## Optimised double-sided lift system for INTRA air suspension units

As part of ongoing technical further development, SAF is now offering an optimised version of the double-sided axle lift systems for INTRA air suspension units.

Illustration for steel hanger bracket

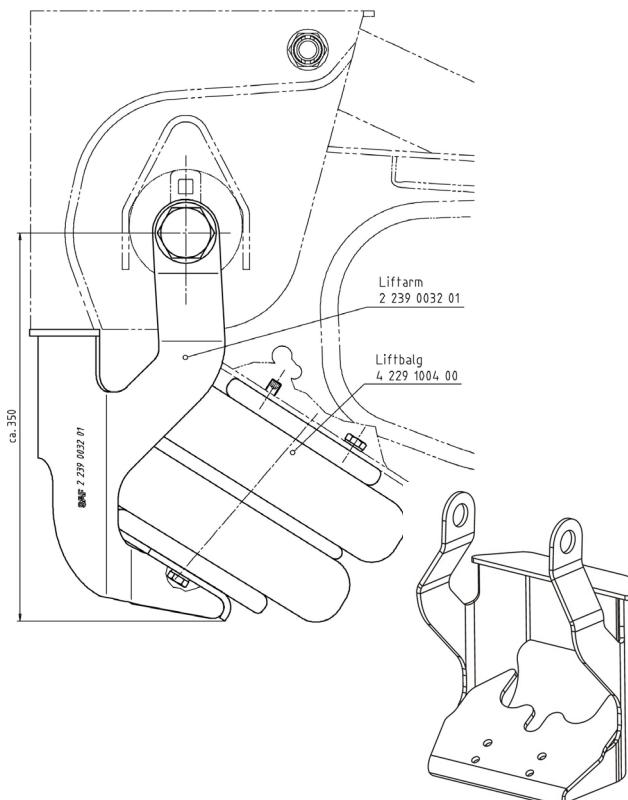
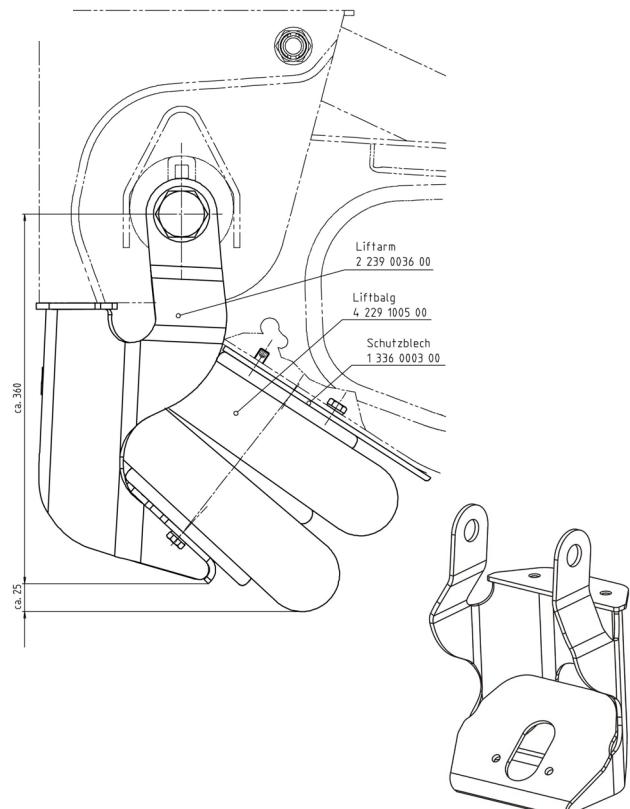
### Lift-Kit-TO DATE

- 3 027 1242 00  
for steel hanger brackets
- 3 027 1243 00  
for cross members
- 3 027 1244 00  
for aluminium hanger brackets

### Lift-Kit-NEW

- 3 027 1242 01  
for steel hanger brackets
- 3 027 1243 01  
for cross members
- 3 027 1244 01  
for aluminium hanger brackets

The optimised double-sided axle lift system replaces the old double-sided axle lift also in all spare parts orders.

Use of the old lift system on one side of the axle and the new lift system on the other side of the axle is permissible.

**Not permissible** is a combination of the new air bellow with the old lift arms or a combination of the old air bellow with the new lift arms. Use of the new air bellow is only permissible in conjunction with the new lift arms.
